The applicant is requesting approval of Eli Estates, a 1.65 acre subdivision for 10 lots, located at 1550 S. Ivy Street, on the east side of S. Ivy Street, just north of SE 16th Avenue, and zoned R-1.5 Medium Density Residential. (SUB 14-03)

SUBDIVISION STAFF REPORT
FILE #: SUB 14-03, ELI ESTATES
Prepared for the June 23, 2014 Planning Commission Meeting

ISUL ENGINEERING Street Profiles *ELI ESTATES*
 Street Sections *ED NETTER CONSTRUCTION*
 375 PORTLAND AVENUE
 GLADSTONE, OREGON 97027
 (503) 657-0188
 07-134-Layout.dwg

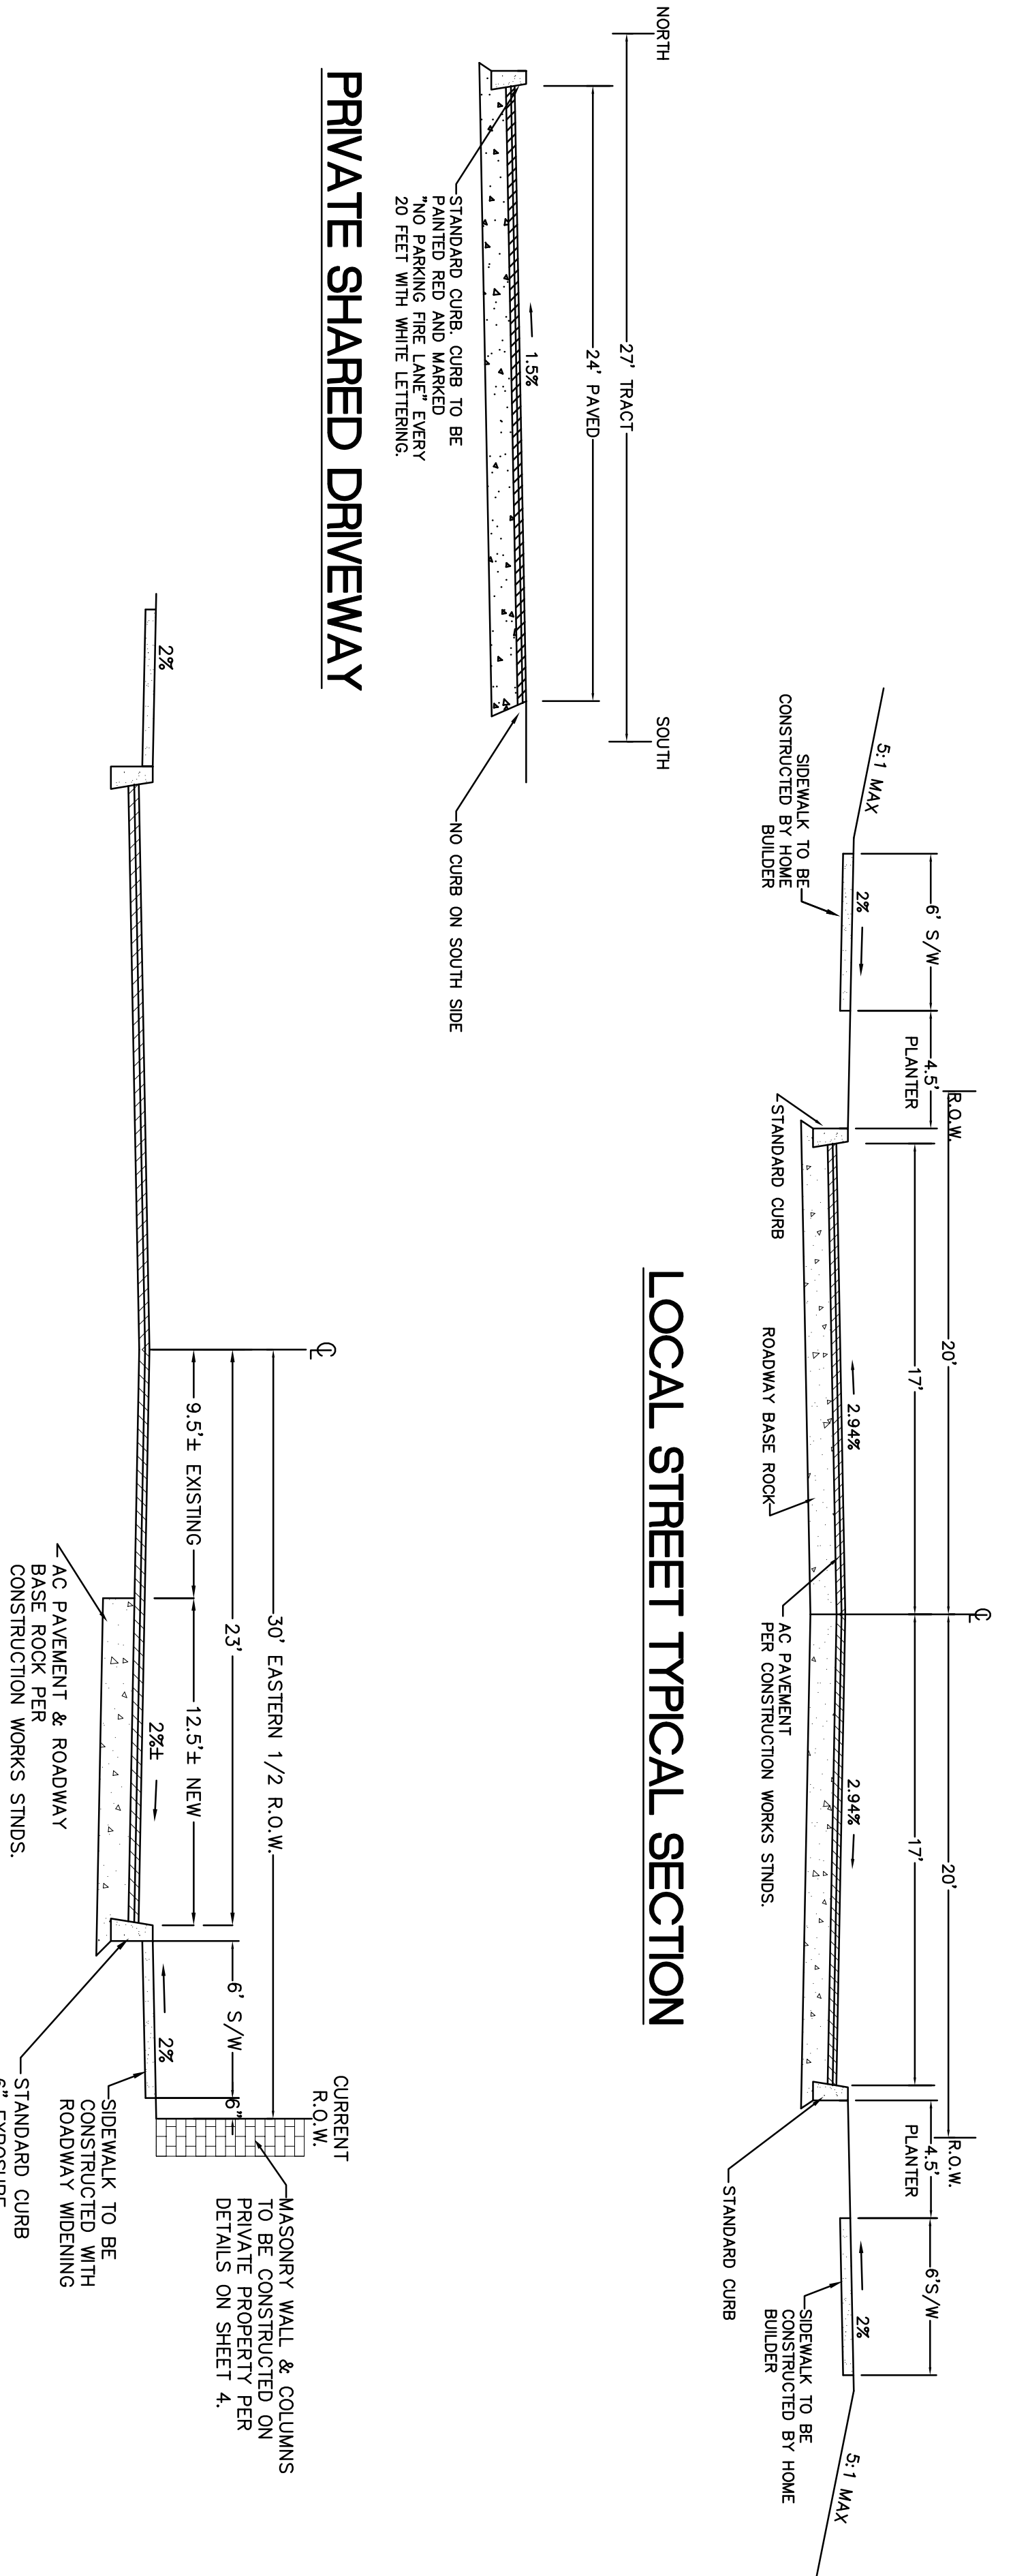
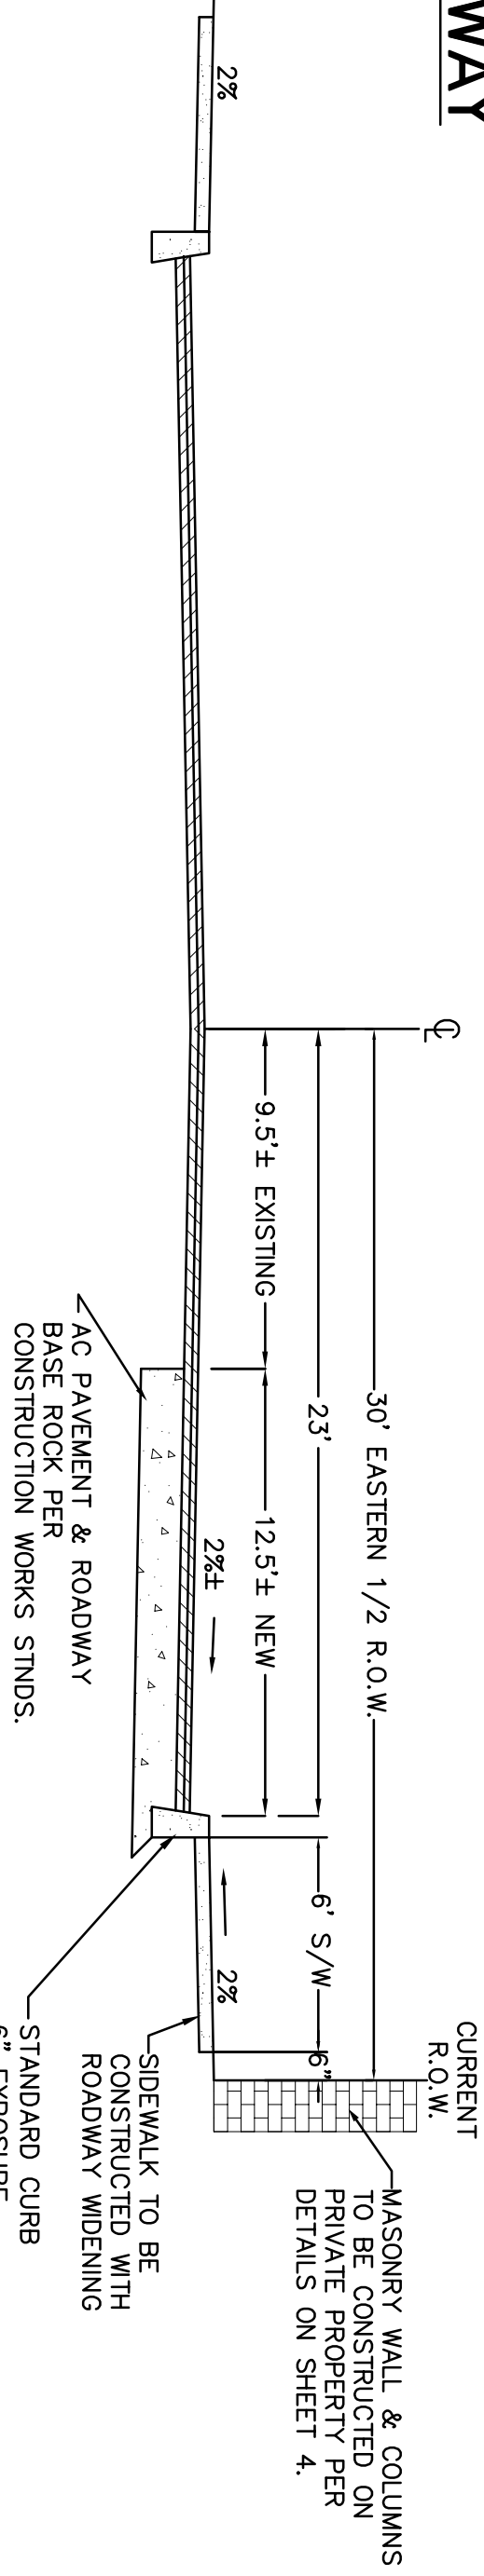
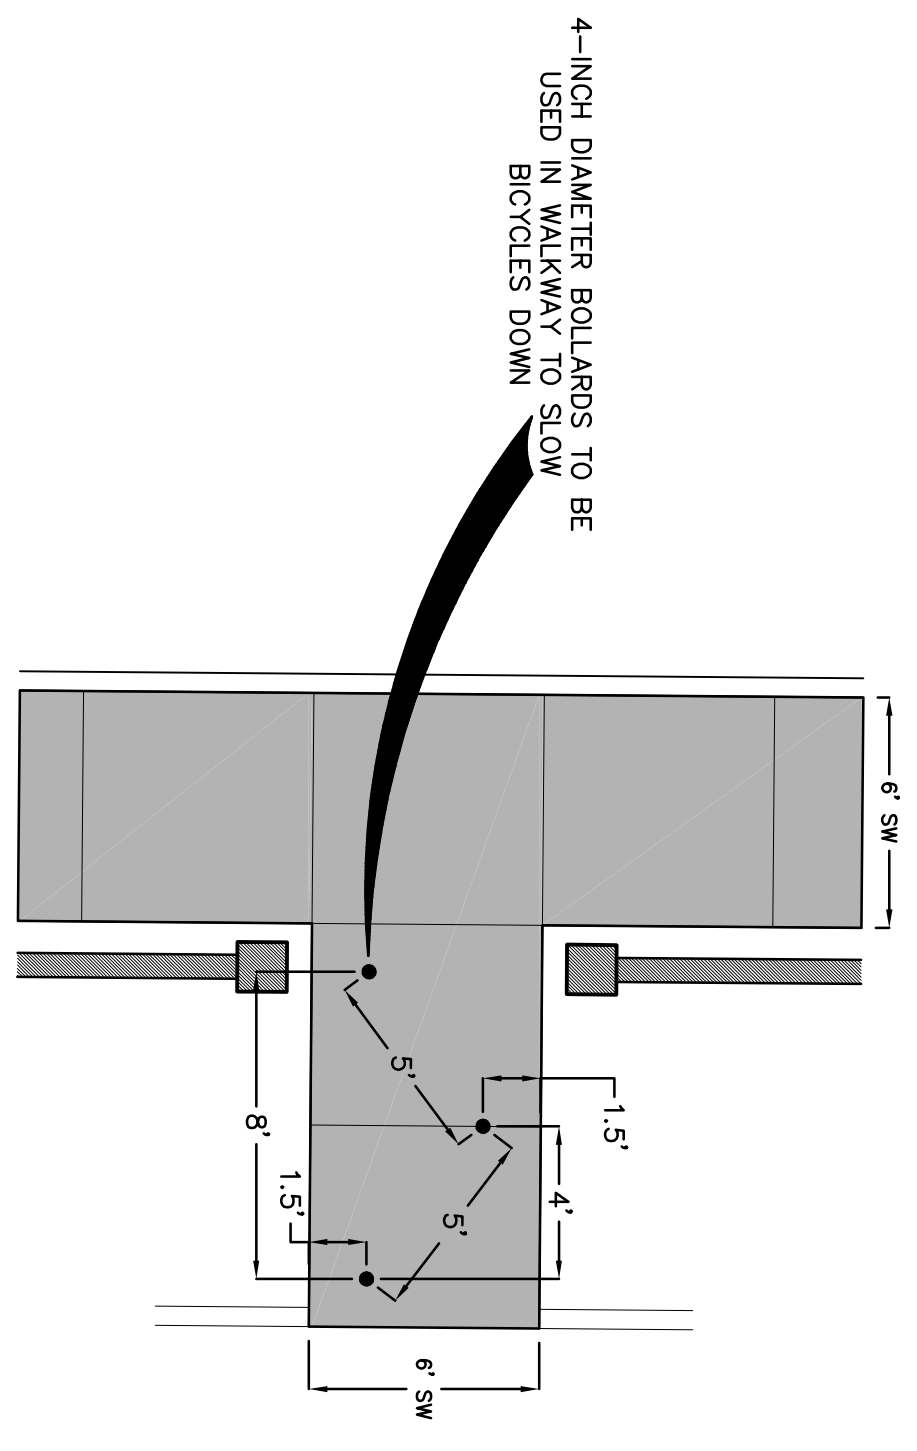
The new interior street is proposed as a public street. A 40 foot wide right of way and 34 feet of pavement is planned, although the new street is partially in a wider knuckle arrangement through much of this development where the right of way is 48 feet. The right-of-way width proposed to match what has been dedicated in neighboring developments and what is planned for Dinsmore Estates 2, in order for the finished developments to have a similar appearance in their setbacks. The street section from curb to curb will be slightly narrower than with Dinsmore Estates (from old standard of 36 feet to new standard of 34 feet) and the sidewalk will be one foot wider on each side (to comply with the new 6-foot standard). A 1 foot narrower street and a one foot wider sidewalk will lead to a consistent planter strip width between old and new

The “knuckle” where SE 15th Place turns northward is built to special standards, with sidewalks and planter strips. This knuckle will have a 48 foot outside curb radius. See Sheet 3 for additional details.

Finding: Both streets in this subdivision are Local Streets, and the design of both SE 15th Place and S Juniper Street generally reflect the required standards. Each street is developed within a 40 foot right of way with a 34 foot paved street section. See Sheet 3 *Street Profiles and Street Sections*.

Finding: Street grades for the two proposed streets in this subdivision will meet the requirements of this section, as illustrated on Sheet 3, *Street Profiles and Street Sections*. In addition, As part of the standard street sections, curbs are provided.

both ends of the street. The improvements shall also include curbs, sidewalks, street lights (per CUB requirements), and utilities in conformance with section 2.207 of the City of Canby Public Works Design Standards dated June 2012. Clackamas County approval will be needed for those improvements. Details in accordance with the applicant's Sheet 3 Street Profiles and Street Sections shall be adhered to.

13. Tract A shall be constructed as shown on the applicant's Sheet 3 Street Profiles and Street Sections,
14. The common driveway (Tract A) shall have a commercial driveway approach using 6" minimum concrete thickness with reinforcements over 4" minimum of crushed rock base.
